## Report to Development Permit Panel

**To:** Development Permit Panel  
**From:** Joe Erceg  
Manager, Development Applications  
**Date:** June 18, 2002  
**File:** DP 02-205860  
**Re:** **Application by David Eaton for a Development Permit at  
9051 and 9071 Beckwith Road**

**SITE PLAN**

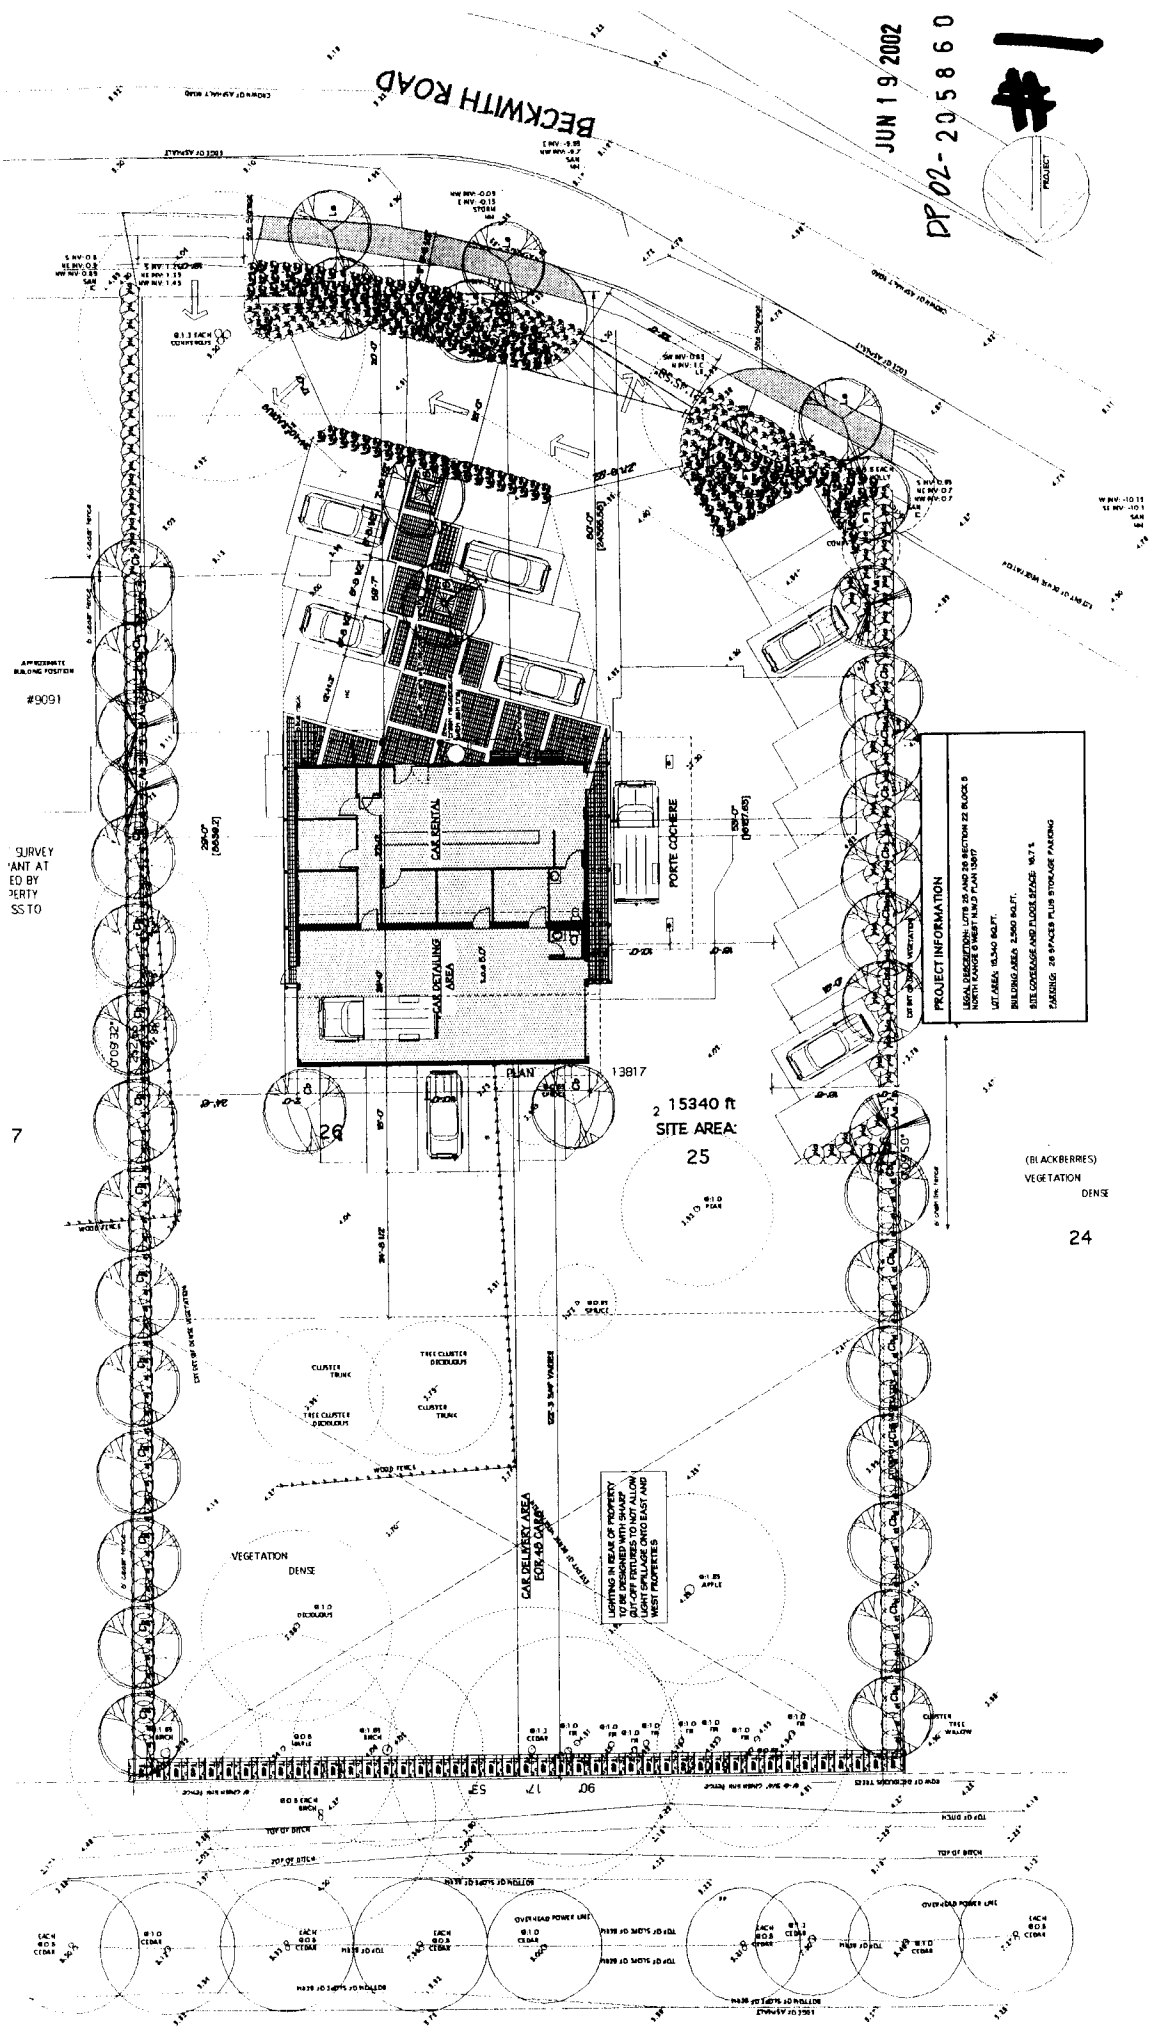
3. Staff would prefer a single driveway access on Beckwith Road and have requested some property dedication to improve the sight lines in front of your property (this property dedication is in fact noted on your site plan). *Transportation staff prefers a combined, single entry point but the applicant prefers a dual access arrangement. Transportation staff agreed to the dual access arrangement provided that the location of the easterly access point was shifted to permit the retention of the large tree in the southeast corner of the site. The City Arborist does not support the retention of this large tree because of conflicts with overhead hydro lines. Therefore, the proposed access points remain as originally proposed by the applicant.*

1. A large tree that should be saved exists in the proposed location of the east entrance. The proposed east entry should be relocated or consolidated into a single entry point.  
*While the existing landmark tree at the southeast corner is assessed as reasonably healthy, it has been pruned to avoid conflicts with overhead hydro lines and therefore the City Arborist has not supported the retention of this tree.*

1. There are numerous issues with respect to the design of the frontage improvements that can be dealt with as part of the review of the Servicing Agreement including:
  - Driveway widths and drop curbs instead of curb returns;
  - Beckwith Road widening and the new curb alignment with increased radius (115 m) transition treatment; and
  - Driveway crossings as per City standard with a maximum width of 5.0 m complete with a continuous sidewalk.

2. The requested property dedication along Beckwith Road was not obtained during the rezoning stage and must be acquired. *Acknowledged by the applicant and the requested property dedication will become a requirement of the Servicing Agreement.*

- *Road widening as deemed necessary by Transportation and Engineering staff including a continuous curb line along the redefined north edge of Beckwith Road with curb let downs rather than curb returns and a maximum 5 m width for both driveways at the vehicle access and egress points;*
- *A continuous 1.5 m sidewalk and 1.5 m grass boulevard complete with street tree where possible complete with street lighting as deemed necessary by Richmond Transportation and Engineering staff;*
- *Dedication of a triangular piece of land along Beckwith Road to permit a smoother transition of the roadway at the existing curve in the road; and*
- *Provision of stamped and sealed drawing(s) by a registered engineer which detail the specific off-site improvements.*

- ***The chain link fence along the west property line has been replaced with a cedar fence;***
- ***The boulevard design has been revised to include a continuous 1.5 m sidewalk with a consistent 1.5 m grass boulevard. The vehicle entries have been changed to driveway crossings and an additional three street tree have been added west of the westerly vehicle entry. In addition, the size of all street trees has been increased to 10 cm (4 inches) in caliper size; and***

LANDSCAPE PLAN

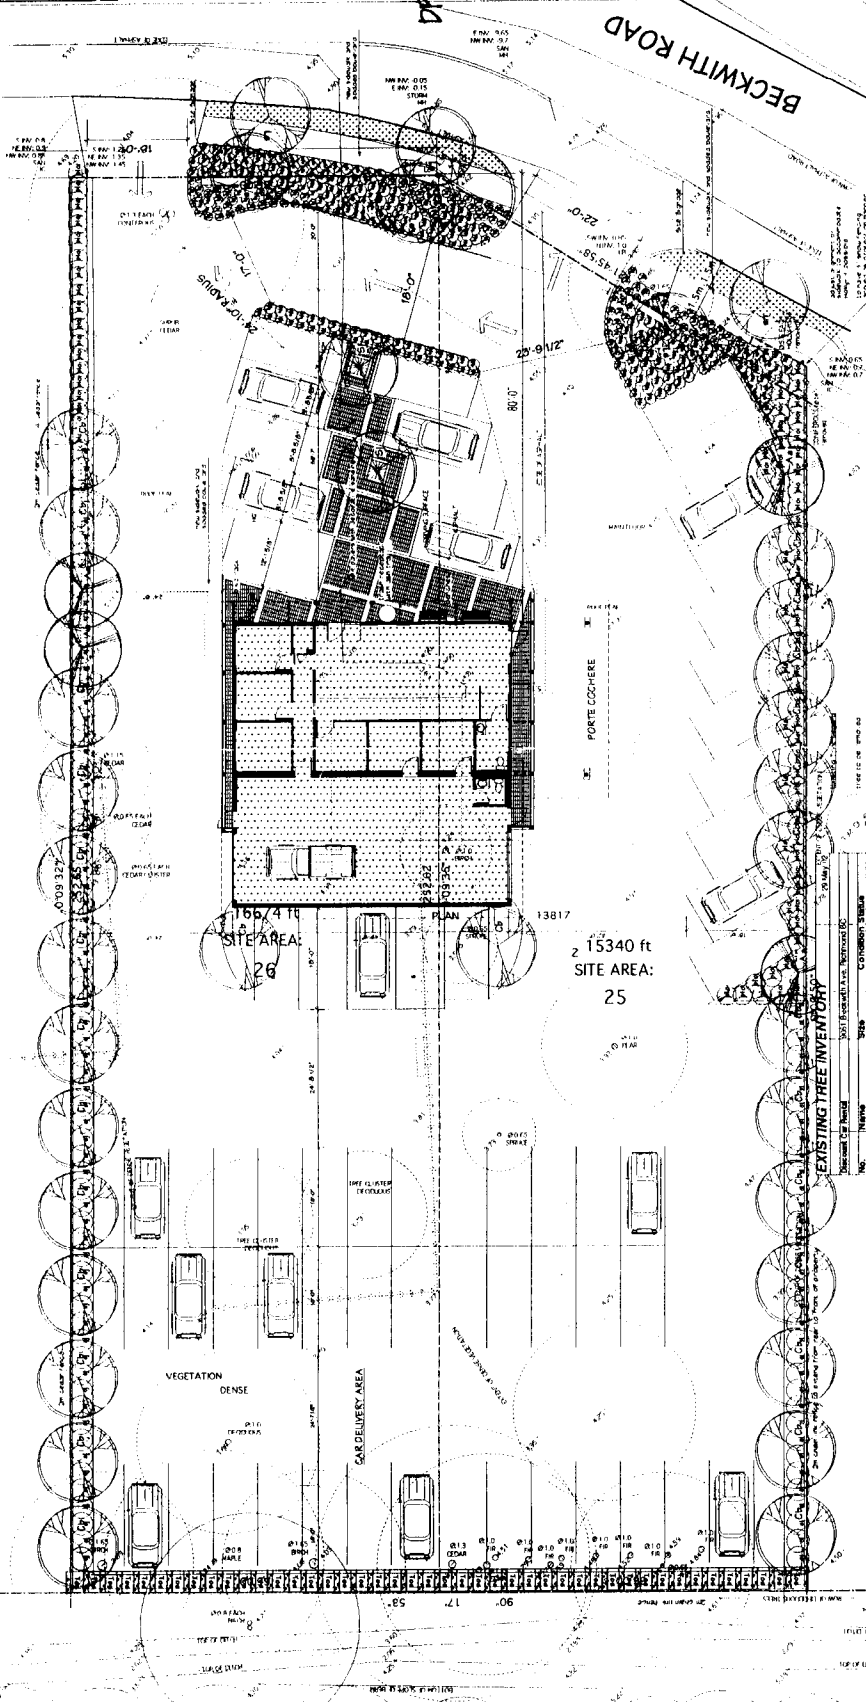
2. Provide two (2) replacement trees at 10 cm (4 inch) caliper in size for each proposed tree removal of 15 cm (6 inch) in caliper size or larger. *The applicant proposes to remove 26 existing site trees that are larger than 15 cm (6 inches) in caliper size and proposes a total of 83 replacement trees of which 34 are 10 cm (4 inches) in caliper size or larger. The proposed replacement tree planting is acceptable to staff.*

3. Provide effective screening along the side and rear yards including fencing, tree and shrub planting. *The subject site is located within the West Bridgeport Sub-Area, which is undergoing a significant transition from older Single-Family Residential, and Industrial land uses to Commercial and Entertainment uses. The subject site is defined by a rail line along the north property line with an industrial storage area beyond. There is an existing single-family residential lot immediately to the east of the subject site and a vacant lot with Residential zoning to the west. The applicant has provided a combination of cedar and chain link fencing, shrub and tree planting around the perimeter of the subject site to the satisfaction of staff.*

- the issue of replacement trees, which was considered problematic by the applicant, and how they could be incorporated onto the site, was questioned;
- it was questioned whether a different structure of landscape could be used instead of replacement trees;

- the scale of plant materials was on the thin side;
- the landscape site planning would differ if trees were to be retained;
- more attempt should be made to save the landmark tree; it was suggested that one centred entrance, with a right turn, would lessen confusion and make use of the internal roadway;

- ***Since City Arborist does not support the retention of the existing site trees, the applicant proposes to remove 26 existing site trees that are larger than 15 cm (6 inches) in caliper size. As compensation, the applicant proposes a total of 83 replacement trees of which 34 are 10 cm (4 inches) in caliper size or larger. The proposed replacement tree planting is assessed as acceptable to staff;***

The Richmond tree replacement guideline indicates that two (2) replacement trees at a minimum 10 cm (4 inch) caliper size should be planted for every one (1) tree removed of 15 cm (6 inch) caliper size or larger. The applicant proposes to remove 26 trees with a caliper size of 15 cm (6 inches) or larger and proposes a total of 83 replacement trees with only 34 trees of 10 cm (4 inches) in caliper size. While the applicant proposes more than the suggested 52 replacement trees, only 34 replacement trees meet the minimum caliper size of 10 cm (4 inches) in the guideline. On balance, staff supports the proposed approach to tree replacement.

SOUTH ELEVATION - BECKWITH STREET

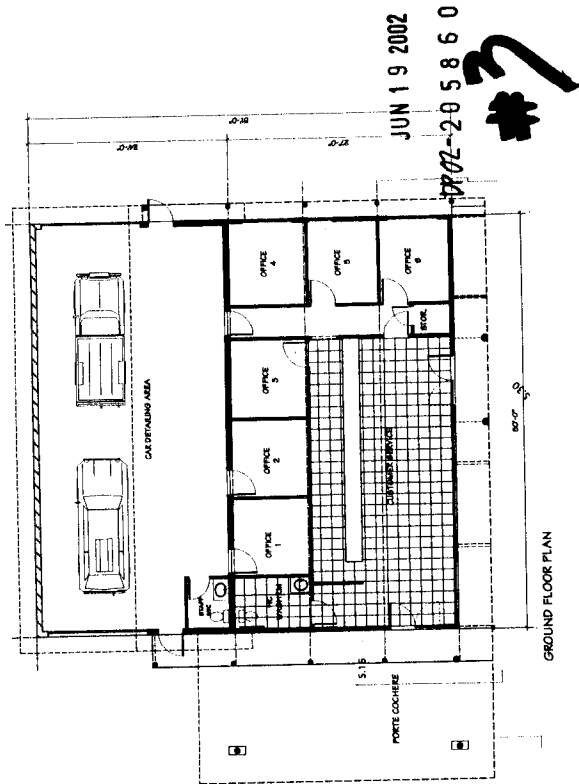
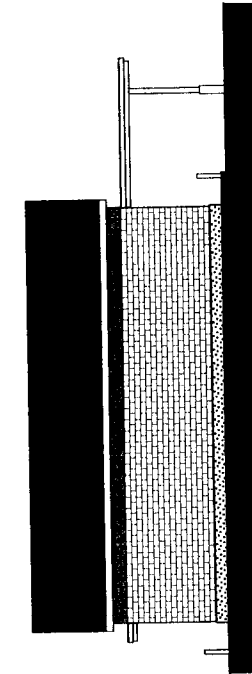
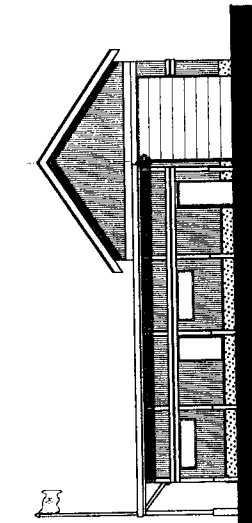
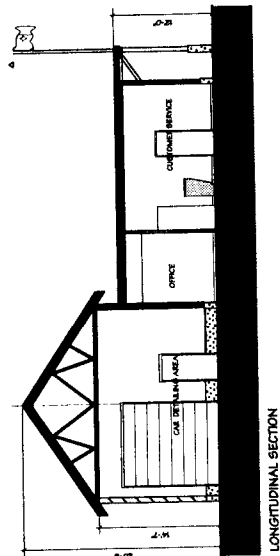
- the unusual building type, which appears residential in scale, was questioned, as was the gabled roof;
- the screening at the sides of the property should be continued to the rear property line;

- the roof line was of concern;
- the issue of precedent was raised regarding the dual entry access;
- it was suggested that more green space could be provided if there was only one access and no internal roadway;

- the lack of plant sizes on the plant list was noted;
- a choice should be made for gabled or flat roof;
- the canopy should be integrated which would aid the presentation to the street – or, should be made completely flat which would make more commercial;

The proposed commercial building is relatively small for the size of the site and while the Advisory Design Panel had several minor comments as noted above staff accepts the architectural design as proposed.
